THE BERMUDA LAKES RV RESORT RVPD

HEARING EXAMINER RECOMMENDATION

REZONING: DCI2014-00010
Applicant: Exit 24 LLC

Regarding: THE BERMUDA LAKES RV RESORT RVPD

MASTER CONCEPT PLAN							
THE BERMUDA LAKES RV RESORT PLANNED DEVELOPMENT							
LEE COUNTY, FLORIDA							
DATE	PROJECT	DRAWING	DESIGN	DRAWN	CHECKED	SCALE	SHEET
5/12/2014	2062NT	MCP		EAH		1"=100'	1

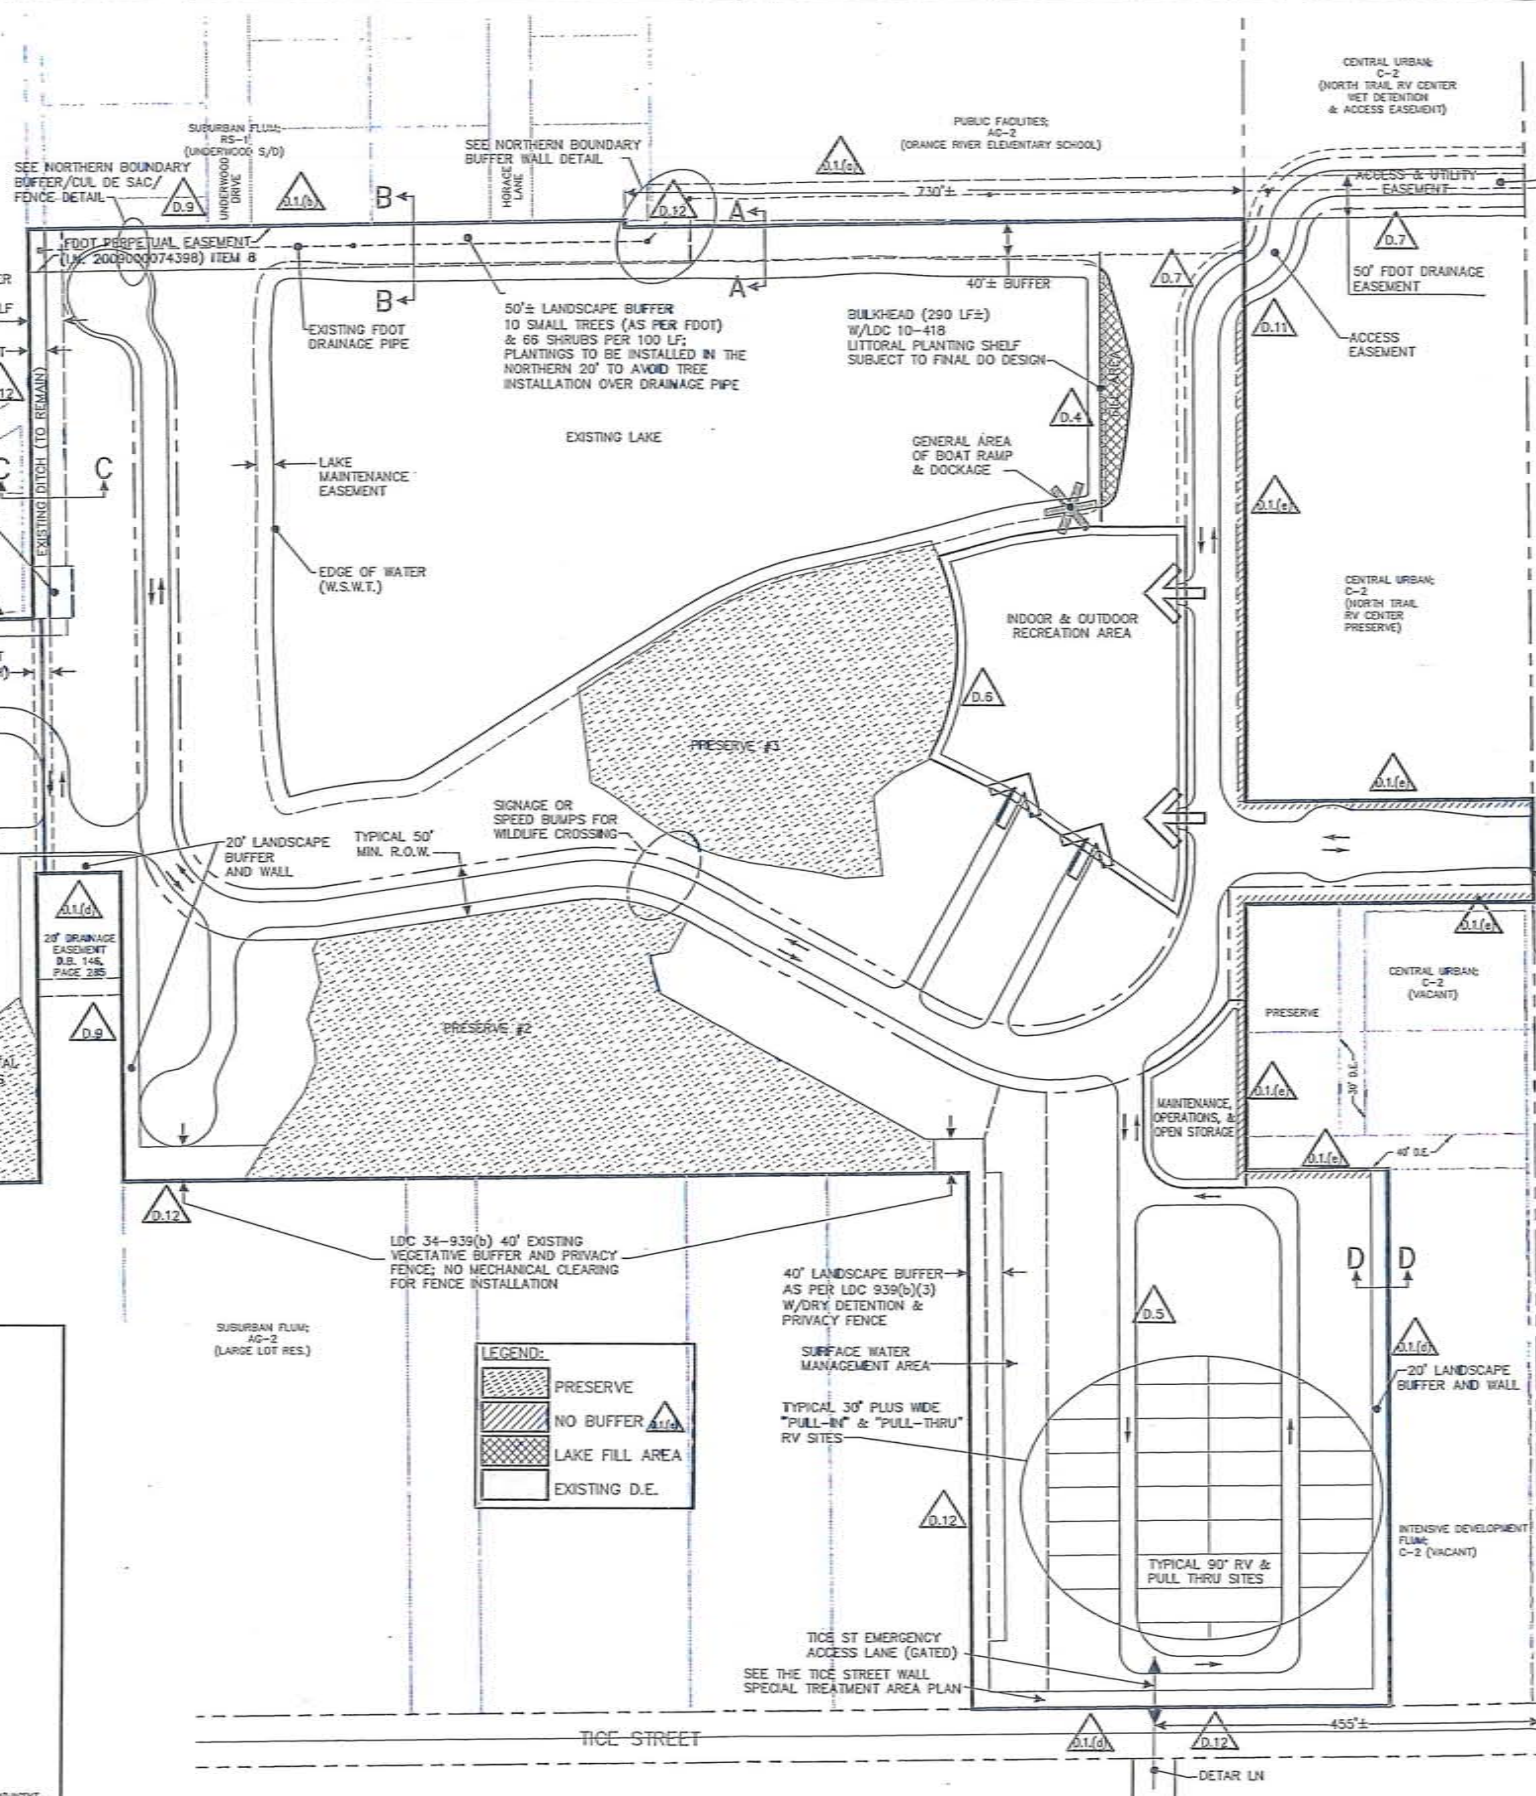
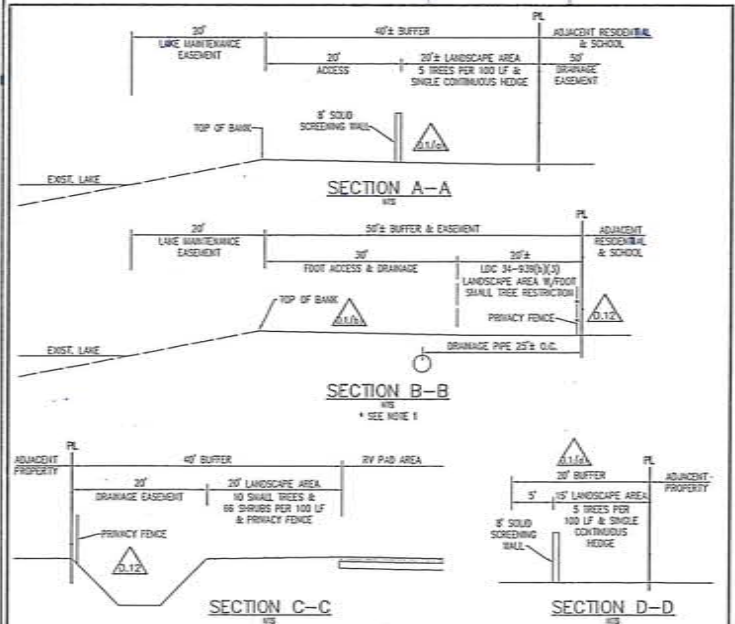
Deviation 2.a. The Applicant seeks to allow the use of the interior 20 feet of the 40-foot wide buffer for the lake maintenance access; the requested deviation omits a relevant LDC provision. One part of the LDC requires a 20-foot wide maintenance easement around the lake, which must remain clear with sufficient vehicle access.⁸⁰ Section A-A on the MCP shows such an easement along the lake, outside of the 40-foot wide buffer area. However, this area has mature trees it is appropriate to retain and, therefore, cannot provide the required vehicle access. The southern 20 feet of the 40-foot wide buffer area could provide the vehicle access,⁸¹ but vehicle accesses are not allowed in the buffer area without a deviation.⁸² Therefore, the Hearing Examiner recommends this deviation be amended to add the second LDC provision⁸³ to allow the lake maintenance access in the portion of the required 40-foot wide buffer north of the existing lake (in the A-A area and the portion next to the lake in the B-B area).

Deviation 2.c. The Request includes a deviation to allow a portion of an internal road cul-de-sac to intrude into the buffer area (part of previous 1b). The requested deviation is to sections of the LDC that specifically prohibit streets and vehicles in required buffer areas.¹⁰¹ However, no deviation can be granted to allow the right-of-way/easement for the road to intrude into the required planted area in the way shown on the MCP.¹⁰²

The Applicant's apparent justification for the requested roadway intrusion is that it will provide more flexibility to place the RV pads in the area.¹⁰³ However, it will bring the pavement end of the main road in the RV park to within 20 feet of the adjacent residential properties. The LDC is very clear that streets are not appropriate in the landscape buffer areas. This appears to be especially true under the extraordinary buffering requirements for RV parks. The potential lot placement flexibility is not sufficient to overcome the intent of the design requirements for buffers and the RVPD district. Granting the deviation would not protect the abutting property owners.¹⁰⁴ The requirement is not unreasonably burdensome to the Applicant.¹⁰⁵ Therefore, the Hearing Examiner recommends denial of the roadway intrusion deviation.

Note: No explanation was provided or deviation requested for the reductions in the width of the RVPD required buffer area on the north and south ends of the western southeast area buffer, shown on the MCP. The buffer area along the entire western side of the southeast area should be 40 feet in width.

Therefore, the Hearing Examiner recommends approval of the added deviation, with a condition to clarify that if impervious surfaces are used for the maintenance access, they cannot exceed 20 percent of the buffer width.⁸⁵ As conditioned, the deviation helps to achieve the objectives of the planned development and provides the maintenance access while preserving the intended buffering.⁸⁶

Therefore, the Hearing Examiner recommends approval of the reduced buffer width and a reduced number of shrubs, but recommends the RVPD required number, size and types of trees be retained and the wall be placed 20 feet from the property boundary. As recommended, this buffer design will help achieve the objectives of the planned development while meeting the intent of the regulations.¹¹¹
